- 1 26 Beattie Avenue, Denistone East - Demolition of existing structures and construction of a two storey child care centre for 68 children and 10 staff with basement parking for 13 vehicles. Proposed hours of operation are 7:00am to 6:00pm Monday to Friday. Approval is also sought for the removal of one (1) street trees - LDA2020/0358 ..... 3

### **City of Ryde Local Planning Panel Report**

<b>DA Number</b>	LDA2020/0358
<b>Site Address &amp; Ward</b>	26 Beattie Avenue, Denistone East Lot 53 in Deposited Plan 9536 Central Ward
<b>Zoning</b>	R2 Low Density Residential
<b>Proposal (as lodged)</b>	Demolition of existing structures and construction of a two storey child care centre for 73 children and 10 staff with basement parking for 14 vehicles. Proposed hours of operation are 7:00am to 6:00pm Monday to Friday.  Approval is also sought for the removal of one (1) street tree.
<b>Proposal (as amended)</b>	Demolition of existing structures and construction of a two storey child care centre for 68 children and 10 staff with basement parking for 13 vehicles. Proposed hours of operation are 7:00am to 6:00pm Monday to Friday.

**Figure 1** Proposed south eastern elevation (Beattie Avenue) Source: Archizen Architects Issue D dated 08/02/2021. This render does not accurately depict the extent of retaining wall and fencing structures which would need to be incorporated into the streetscape for safety purposes.

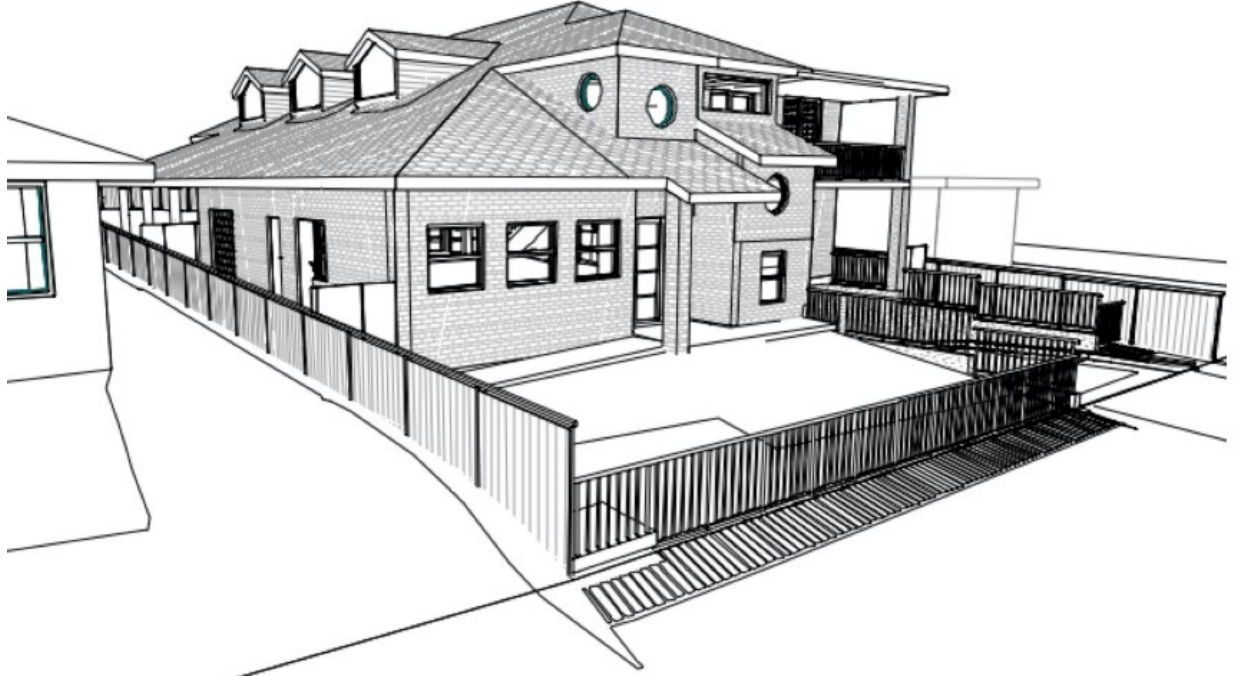
The proposal is not considered to be designed in response to the site's topography. The proposal incorporates basement parking and necessitates extensive cut across the entire site with reliance upon retaining walls within the front, side and rear setbacks. The proposed basement garage necessitates retaining walls within the front setback adjoining the driveway in addition to balustrading in response to the created level differences. This contributes to uncharacteristic visual presentation to the streetscape, which is not responsive to the site's topography.

**Comment:** The proposal is considered to be contrary of the established streetscape character. Concern is held regarding the proposed basement level, extent of excavation across the site, the provisions of retaining walls within the front setback and the resultant traffic impacts associated with the use. These form part of the recommendation for refusal.

Figure 2 Extract of proposed basement plan Source: Archizen Architects Issue D dated 08-02-2021

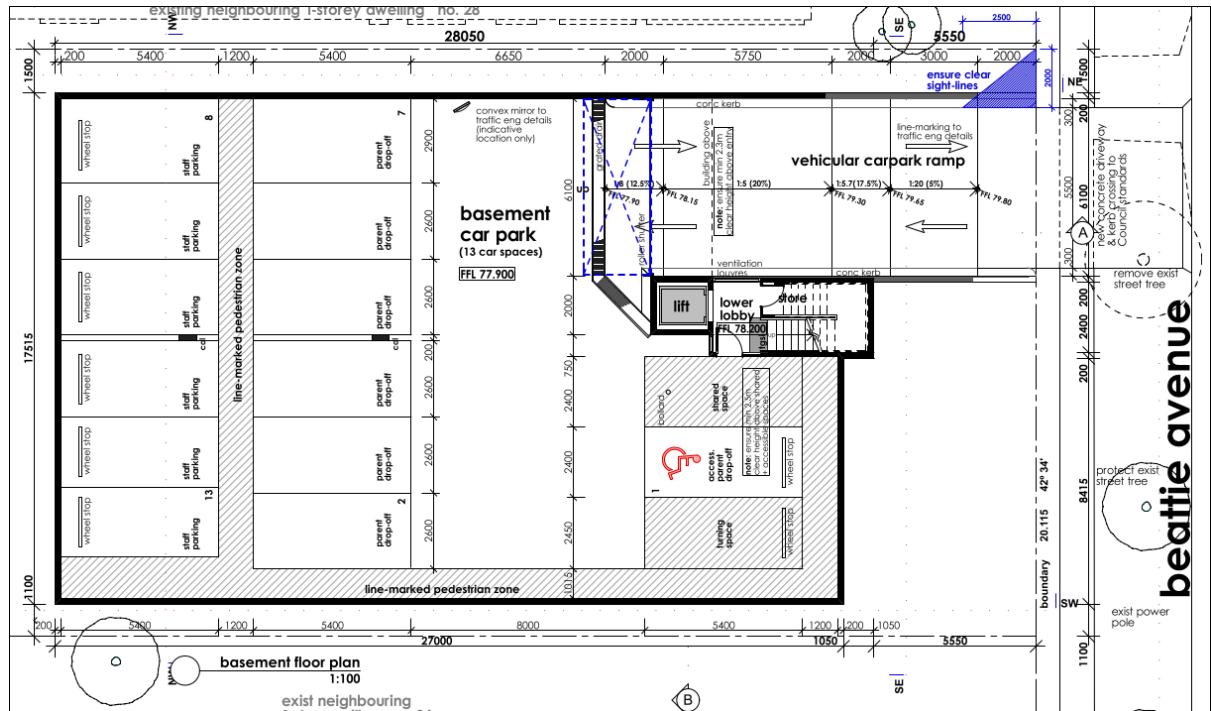
*The proposed pathway does not provide effective separation between pedestrian movements and vehicles entering and exiting parking spaces within the basement car park. The small ages of students of the childcare facility is such that an unattended child wandering within this pathway unattended may be unseen by a driver entering a parking space adjacent to this pathway, which represents a significant safety risk.*

- The proposal provides insufficient car parking which will have an adverse impact on traffic volumes, traffic movements, pedestrian safety and demand for on street parking.
- The proposed design of the basement car park is considered to be undesirable and unsafe as it does not provide effective separation between pedestrian movements along this pathway and vehicles entering and exiting parking spaces within the basement car park.
- The proposal exceeds the maximum 1.2m excavation permitted under Clause 2.6.2(b) in Part 3.3 of the Ryde DCP 2014.

*A 1.2m wide pedestrian path is proposed separating the tandem staff and visitor parking spaces. This design is considered to be undesirable and unsafe as it does not provide effective separation between pedestrian movements along this pathway and vehicles entering and exiting parking spaces within the basement car park. The small ages of students of the childcare facility is such that an unattended child wandering within this pathway unattended may be unseen by a driver entering a parking space adjacent to this pathway, which represents a significant safety risk.*

Figure 7 Exit points for the 50 children at first floor to access the outdoor play space

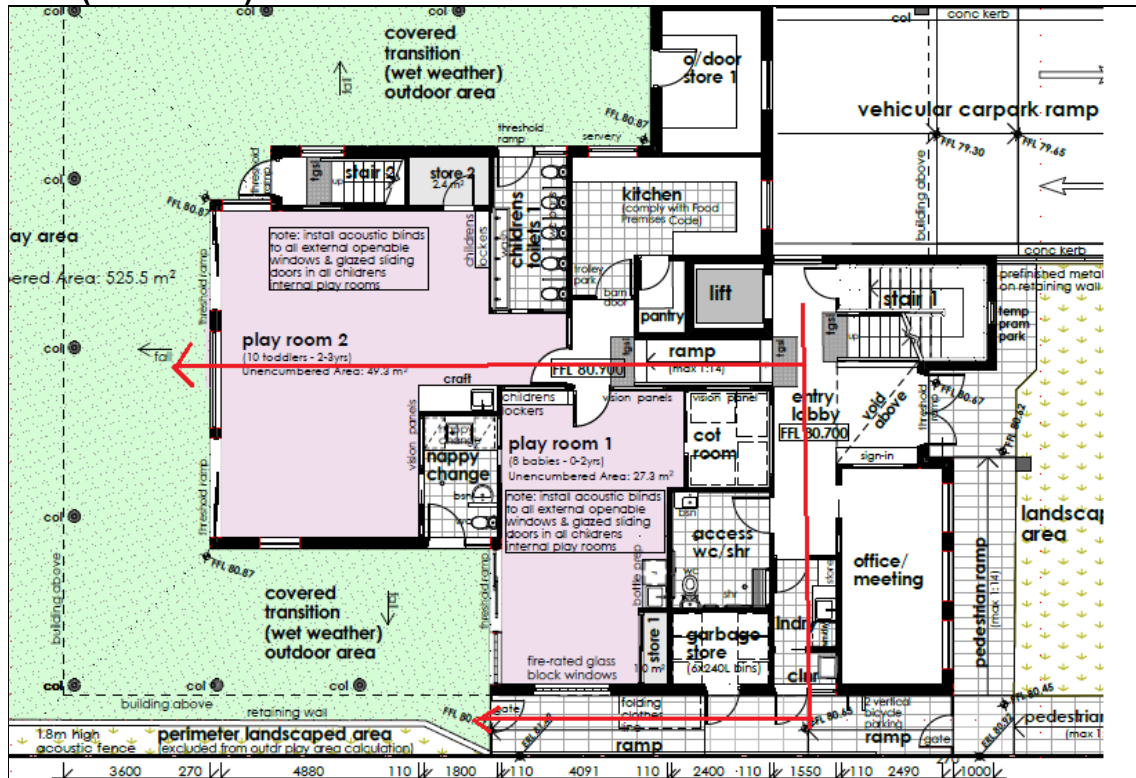
At first floor level the proposal includes play rooms 3 and 4 associated with fifty (50) children aged 3-5 years. The proposal has not been designed to provide a direct

The building design is not considered to be fit for purpose and does not deliver a high level of amenity for children. Access to the sunken outdoor play areas is convoluted and does not provide good opportunity for enjoyable and easy to use spaces.

The children are required to travel to the ground floor and then either exit through play room 2 or through the laundry and cleaners room and travel along the south western side boundary as shown in **Figure 12**. The exit through play room 2 would have implications for the use of this space by the designated 10 toddlers. The other exit which relies upon children going through a 1.55m wide laundry and cleaner's room. Both access points require a travel distance of approximately 27 metres. The access is considered non direct and is contrary to the intent of having a connection between the indoor and outdoor learning spaces for child care centres.
